TIMBERLANE TERRACE - THIRD ADDITION

VICINITY MAP & PLAN INDEX
STORM SYSTEM A & STEPPED SWALES
RECORD DRAWING

STORMWATER DRAINAGE PLAN

RECORD DRAWING

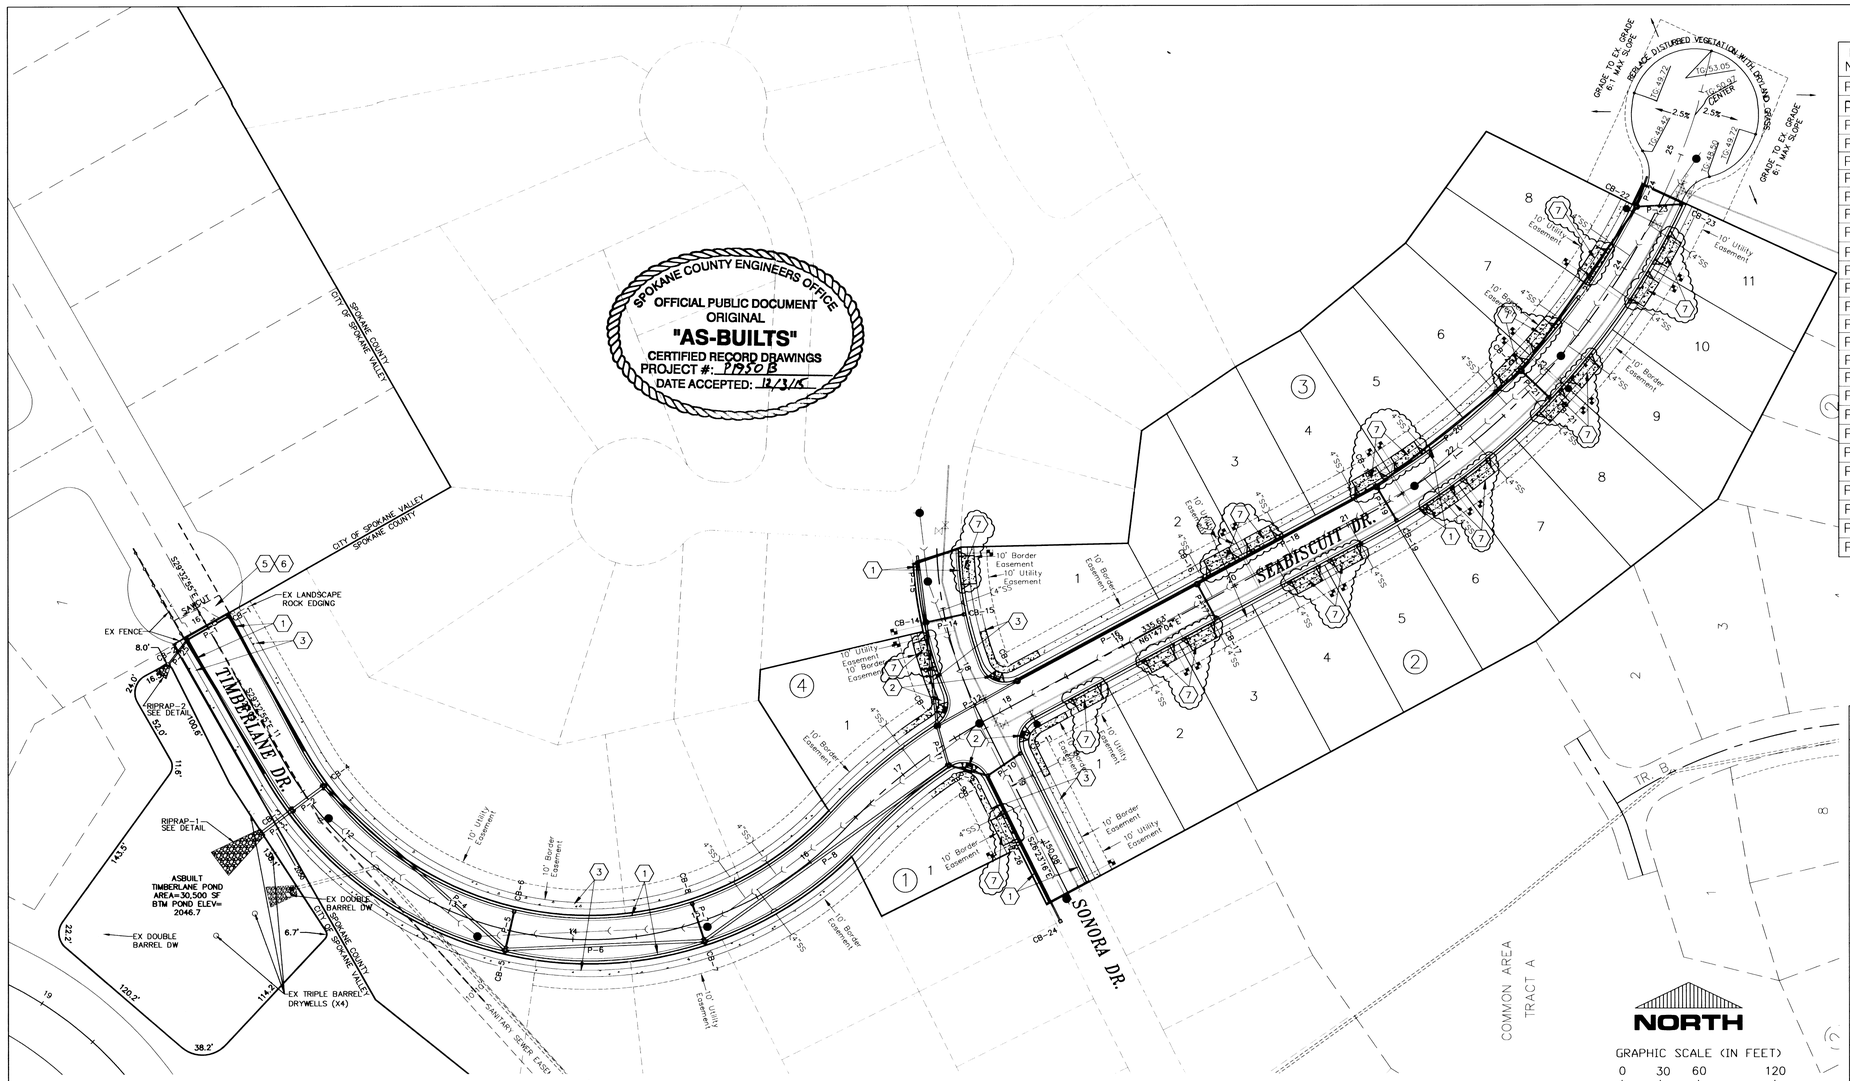
PIPE NAME	I.D.	PIPE TYPE	APPROX. LENGTH	APPROX. SLOPE	ASB. SLOPE	UPSTREAM NODE	UPSTREAM INVERT	DOWNSTREAM NODE	DOWNSTREAM INVERT
P-1	8"	D.I.	30'	~~0.004~~	0.004	CB-1	~~2047.31~~	CB-2	~~2047.19~~
P-2	24"	H.D.P.E. ~~/PVC~~	30'	~~0.020~~	0.016	CB-4	~~2048.05~~	CB-3	~~2047.44~~
P-3	24"	H.D.P.E. ~~/PVC~~	28'	~~0.016~~	0.024	CB-3	~~2047.44~~	POND	~~2047.00~~
P-4	24"	H.D.P.E. ~~/PVC~~	191'	~~0.066~~	0.068	CB-5	~~2060.67~~	CB-4	~~2048.05~~
P-5	8"	~~H.D.P.E.~~ /PVC	30'	~~0.005~~	0.022	CB-6	~~2061.98~~	CB-5	~~2061.83~~
P-6	24"	H.D.P.E. ~~/PVC~~	156'	~~0.077~~	0.077	CB-7	~~2072.73~~	CB-5	~~2060.67~~
P-7	8"	~~H.D.P.E.~~ /PVC	30'	~~0.005~~	0.005	CB-8	~~2074.05~~	CB-7	~~2073.90~~
P-8	24"	H.D.P.E. ~~/PVC~~	235'	~~0.058~~	0.052	CB-9	~~2086.35~~	CB-7	~~2072.73~~
P-9	12"	H.D.P.E. ~~/PVC~~	31'	~~0.157~~	0.223	CB-10	~~2092.22~~	CB-9	~~2087.35~~
P-10	10"	H.D.P.E. ~~/PVC~~	30'	~~0.005~~	0.005	CB-11	~~2092.53~~	CB-10	~~2092.38~~

P-11	24"	H.D.P.E. ~~/PVC~~	32'	~~0.020~~	0.071	CB-12	~~2086.98~~	CB-9	~~2086.35~~
P-12	15"	H.D.P.E. ~~/PVC~~	72'	~~0.109~~	0.112	CB-13	~~2094.83~~	CB-12	~~2086.98~~
P-13	24"	H.D.P.E. ~~/PVC~~	81'	~~0.008~~	0.010	CB-14	~~2087.63~~	CB-12	~~2086.98~~
P-14	10"	H.D.P.E. ~~/PVC~~	30'	~~0.010~~	0.011	CB-15	~~2092.04~~	CB-14	~~2091.74~~
P-15	24"	H.D.P.E. ~~/PVC~~	52'	~~0.015~~	0.018	CAPPED	2088.51	CB-14	~~2087.73~~
P-16	15"	H.D.P.E. ~~/PVC~~	141'	~~0.080~~	0.080	CB-16	~~2106.06~~	CB-13	~~2094.83~~
P-17	10"	H.D.P.E. ~~/PVC~~	30'	~~0.005~~	0.005	CB-17	~~2106.88~~	CB-16	~~2106.73~~
P-18	15"	H.D.P.E. ~~/PVC~~	160'	~~0.080~~	0.081	CB-18	~~2118.92~~	CB-16	~~2106.06~~
P-19	10"	H.D.P.E. ~~/PVC~~	30'	~~0.005~~	0.005	CB-19	~~2119.74~~	CB-18	~~2119.59~~
P-20	12"	H.D.P.E. ~~/PVC~~	145'	~~0.086~~	0.080	CB-20	~~2130.85~~	CB-18	~~2119.17~~
P-21	8"	~~H.D.P.E.~~ /PVC	30'	~~0.005~~	0.011	CB-21	~~2131.67~~	CB-20	~~2131.52~~
P-22	12"	H.D.P.E. ~~/PVC~~	158'	~~0.067~~	0.069	CB-22	~~2141.50~~	CB-20	~~2130.85~~

P-23	8"	~~H.D.P.E.~~ /PVC	35'	~~0.030~~	0.029	CB-23	~~2143.23~~	CB-22	~~2142.17~~
P-24	12"	H.D.P.E. ~~/PVC~~	25'	~~0.048~~	0.046	CAPPED	2142.70	CB-22	~~2141.50~~
P-25	12"	D.I.	23'	~~0.004~~	0.028	CB-2	~~2147.09~~	POND	~~2147.00~~
P-26	12"	H.D.P.E. ~~/PVC~~	125'	~~0.032~~	0.090	CB-24	~~2096.22~~	CB-9	~~2092.22~~

NAME	LOCATION	STRUCTURE & GRATE TYPE SPOKANE COUNTY & DOT STDS.	GRATE ELEV.	SUMP ELEV.	INVERT ELEVATIONS
CB-1	TIMBERLANE 10+02 Lt.	CATCH BASIN TYPE 1 METAL FRAME TYPE 1 GRATE TYPE 1	~~2049.03~~ 2049.32	~~2045.80~~ 2046.09	IE OUT(8"SW) = ~~2047.31~~ 2047.47
CB-2	TIMBERLANE 10+02 Rt.	CATCH BASIN TYPE 1 METAL FRAME TYPE 1 GRATE TYPE 1	2049.03	2045.59	IE IN (8"NE) = ~~2047.19~~ 2047.34 IE OUT (12"SW) = ~~2047.09~~ 2047.24
CB-3	TIMBERLANE 11+56.73 Rt.	CATCH BASIN 54" TYPE 2 (WSDOT) RECTANGULAR FRAME (WSDOT) RECTANGULAR VANED GRATE (WSDOT)	~~2053.03~~ 2053.12	~~2045.44~~ 2045.53	24" IN FROM NE (P-2) = ~~2047.44~~ 2047.27 24" OUT TO SW (P-3) = ~~2047.44~~ 2047.27
CB-4	TIMBERLANE 11+56.73 Lt.	CATCH BASIN 54" TYPE 2 (WSDOT) RECTANGULAR FRAME (WSDOT) RECTANGULAR VANED GRATE (WSDOT)	~~2053.03~~ 2053.11	~~2046.05~~ 2045.13	24" IN FROM SE (P-4) = ~~2048.05~~ 2047.76 24" OUT TO SW (P-2) = ~~2048.05~~ 2047.76

CB-5	TIMBERLANE 13+50 Rt.	CATCH BASIN 54" TYPE 2 (WSDOT) RECTANGULAR FRAME (WSDOT) RECTANGULAR VANED GRATE (WSDOT)	~~2065.33~~ 2065.23	~~2058.67~~ 2058.57	24" IN FROM EAST (P-6) = 2060.67 8" IN FROM NORTH (P-5) = 2061.83 24" OUT TO NW (P-4) = 2060.67
CB-6	TIMBERLANE 13+50 Lt.	CATCH BASIN TYPE 1 METAL FRAME TYPE 1 GRATE TYPE 1	~~2065.33~~ 2065.80	~~2060.48~~ 2060.95	8" OUT TO SOUTH (P-5) = ~~2061.98~~ 2062.50
CB-7	TIMBERLANE 15+00 Rt.	CATCH BASIN 54" TYPE 2 (WSDOT) RECTANGULAR FRAME (WSDOT) RECTANGULAR VANED GRATE (WSDOT)	2077.33	2070.73	24" IN FROM NE (P-8) = ~~2072.73~~ 2072.30 8" IN FROM NORTH (P-7) = ~~2073.90~~ 2073.40 24" OUT TO WEST (P-6) = ~~2072.73~~ 2072.30
CB-8	TIMBERLANE 15+00 Lt.	CATCH BASIN TYPE 1 METAL FRAME TYPE 1 GRATE TYPE 1	2077.33	2072.55	8" OUT TO SOUTH (P-7) = ~~2074.05~~ 2073.55
CB-9	TIMBERLANE 17+33.69 Rt.	CATCH BASIN 48" TYPE 2 (WSDOT) RECTANGULAR FRAME (WSDOT) RECTANGULAR VANED GRATE (WSDOT)	~~2093.52~~ 2093.57	~~2084.35~~ 2084.40	12" IN FROM EAST (P-9) = ~~2087.35~~ 2085.42 24" IN FROM NORTH (P-11) = ~~2086.35~~ 2084.42 24" OUT TO SW (P-8) = ~~2086.35~~ 2084.42

CB-10	SONORA 18+84.01 Rt.	CATCH BASIN TYPE 1 METAL FRAME TYPE 1 GRATE TYPE 1	~~2096.11~~ 2095.53	~~2090.72~~ 2090.14	10" IN FROM NE (P-10) = ~~2092.38~~ 2092.40 12" IN FROM EAST (P-26) = ~~2092.22~~ 2092.33 12" OUT TO WEST (P-9) = ~~2092.22~~ 2092.33
CB-11	SONORA 18+79.76 Lt.	CATCH BASIN TYPE 1 METAL FRAME TYPE 2 GRATE TYPE 3	~~2096.00~~ 2096.08	~~2091.03~~ 2091.11	10" OUT TO SW (P-10) = ~~2092.53~~ 2092.55
CB-12	TIMBERLANE 17+43.40 Lt.	CATCH BASIN 54" TYPE 2 (WSDOT) RECTANGULAR FRAME (WSDOT) RECTANGULAR VANED GRATE (WSDOT)	~~2094.02~~ 2093.89	~~2084.98~~ 2084.85	15" IN FROM NORTH (P-13) = ~~2086.98~~ 2086.69 24" IN FROM NE (P-12) = ~~2086.98~~ 2086.69 24" OUT TO SOUTH (P-11) = ~~2086.98~~ 2086.69
CB-13	SEABISCUIT 18+14.26 Lt.	CATCH BASIN 48" TYPE 2 (WSDOT) RECTANGULAR FRAME (WSDOT) RECTANGULAR VANED GRATE (WSDOT)	2098.33	2092.83	15" IN FROM NE (P-16) = ~~2094.83~~ 2094.75 15" OUT TO SW (P-12) = ~~2094.83~~ 2094.75

CB-14	SONORA 17+58.11 Rt.	CATCH BASIN 48" TYPE 2 (WSDOT) RECTANGULAR FRAME (WSDOT) RECTANGULAR BI-DIRECTIONAL VANED GRATE (WSDOT)	~~2095.04~~ 2095.82	2085.63 2085.41	24" IN FROM NORTH (P-15) = ~~2087.73~~ 2087.57 10" IN FROM EAST (P-14) = ~~2091.74~~ 2091.58 24" OUT TO SOUTH (P-13) = ~~2087.63~~ 2087.47
CB-15	SONORA 17+58.11 Lt.	CATCH BASIN TYPE 1 METAL FRAME TYPE 2 GRATE TYPE 3	~~2095.04~~ 2094.92	~~2090.54~~ 2090.42	10" OUT TO WEST (P-14) = ~~2092.04~~ 2091.92
CB-16	SEABISCUIT 19+74.26 Lt.	CATCH BASIN 48" TYPE 2 (WSDOT) RECTANGULAR FRAME (WSDOT) RECTANGULAR VANED GRATE (WSDOT)	2110.76	2104.06	15" IN FROM NE (P-18) = ~~2106.06~~ 2105.96 10" IN FROM SE (P-17) = ~~2106.73~~ 2106.63 15" OUT TO SW (P-16) = ~~2106.06~~ 2105.96
CB-17	SEABISCUIT 19+74.26 Rt.	CATCH BASIN TYPE 1 METAL FRAME TYPE 1 GRATE TYPE 1	2110.76	2105.38	10" OUT FROM NW (P-17) = ~~2106.88~~ 2106.78
CB-18	SEABISCUIT 21+35.01 Lt.	CATCH BASIN 48" TYPE 2 (WSDOT) RECTANGULAR FRAME (WSDOT) RECTANGULAR VANED GRATE (WSDOT)	~~2123.62~~ 2123.51	~~2116.92~~ 2116.81	12" IN FROM NE (P-20) = 2119.17 2119.09 10" IN FROM SE (P-19) = 2119.59 2119.51 15" OUT TO SW (P-18) = 2118.92 2118.84

CB-19	SEABISCUIT 21+35.01 Rt.	CATCH BASIN TYPE 1 METAL FRAME TYPE 1 GRATE TYPE 1	~~2123.62~~ 2123.46	~~2118.24~~ 2118.08	10" OUT TO NW (P-19) = ~~2119.74~~ 2119.66
CB-20	SEABISCUIT 22+85.10 Lt.	CATCH BASIN 48" TYPE 2 (WSDOT) RECTANGULAR FRAME (WSDOT) RECTANGULAR VANED GRATE (WSDOT)	2135.55	2128.85	8" IN FROM SE (P-21) = ~~2131.52~~ 2131.39 12" IN FROM NE (P-22) = ~~2130.85~~ 2130.72 12" OUT TO SW (P-20) = ~~2130.85~~ 2130.72
CB-21	SEABISCUIT 22+85.10 Rt.	CATCH BASIN TYPE 1 METAL FRAME TYPE 1 GRATE TYPE 1	2135.55	2130.17	8" OUT TO NW (P-21) = ~~2131.67~~ 2131.71
CB-22	SEABISCUIT 24+47.72 Lt.	CATCH BASIN 48" TYPE 2 (WSDOT) RECTANGULAR FRAME (WSDOT) RECTANGULAR VANED GRATE (WSDOT)	~~2146.20~~ 2146.15	~~2139.50~~ 2139.45	8" IN FROM SE (P-23) = ~~2142.17~~ 2142.22 12" IN FROM NE (P-24) = ~~2141.50~~ 2141.55 12" OUT TO SW (P-22) = ~~2141.50~~ 2141.55
CB-23	SEABISCUIT 24+64.61 Rt.	CATCH BASIN TYPE 1 METAL FRAME TYPE 1 GRATE TYPE 1	2147.12	2141.73	8" OUT TO NW (P-23) = 2143.23

CB-24	SONORA 20+11.57 Rt.	CATCH BASIN TYPE 1 METAL FRAME TYPE 1 GRATE TYPE 1	2101.04	2094.72	12" OUT TO NW (P-26) = ~~2096.22~~ 2090.76

FABRIC INSTALLED, BUT NO ROCK AS OF 11/24/2015

PLAN-PROFILE: SONORA DRIVE

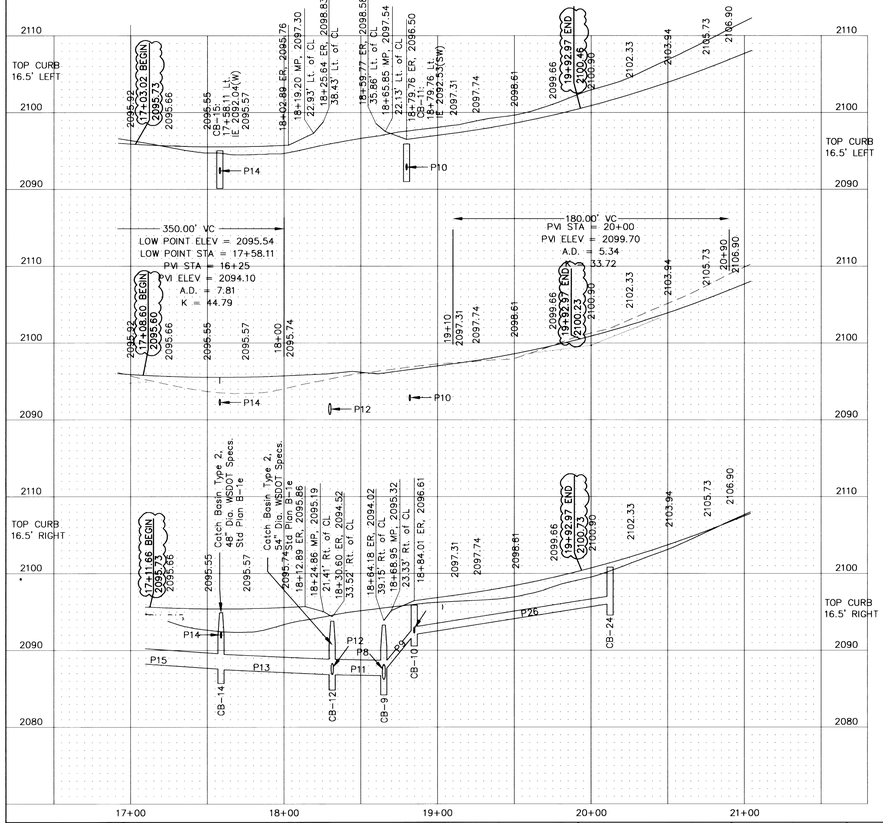
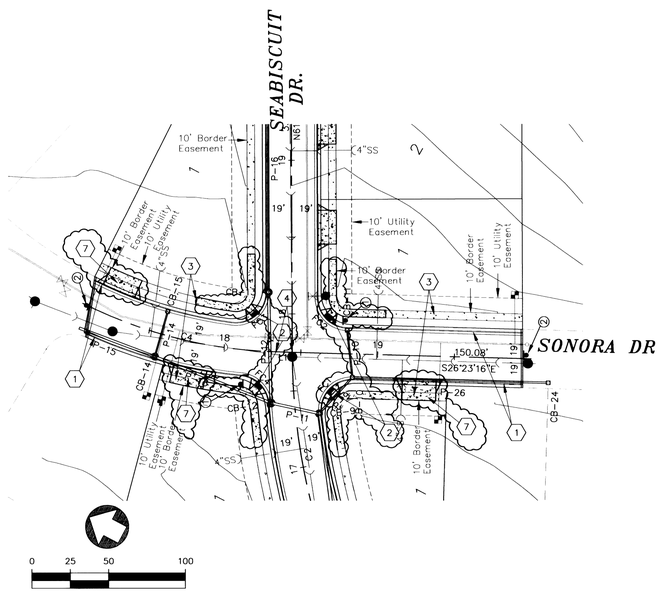
1. CONSTRUCT CONCRETE TYPE "B" CURB, SPO. CO. STDS. SHEET A-3
2. CONSTRUCT DESIGN ~~"A"~~ "B" CURB RAMP, SPO. CO. STDS. SHEET A-5
3. CONSTRUCT 5' WIDE CONCRETE SIDEWALK, SPO. CO. STDS. SHEET A-1
4. STREET MONUMENT TO BE SET BY SIMPSON ENGINEERS
5. SAWCUT EXISTING ASPHALT (CURB TO CURB) 16' NORTHWEST OF PROPERTY LIMITS, APPROXIMATELY 1' NORTHWEST OF EXISTING EDGE OF PAVEMENT. INSTALL NEW STREET SECTION TO MATCH PROPOSED TIMBERLANE DRIVE STREET SECTION.
6. BLEND ASPHALT FROM SAWCUT LINE TO PROPOSED EDGE OF TIMERBERLANE DRIVE WHILE MAINTAINING EXISTING DRAINAGE PATH TO THE NORTHWEST.
7. INSTALL 22' WIDE DRIVEWAY PER SPOKANE CNTY STD A-4
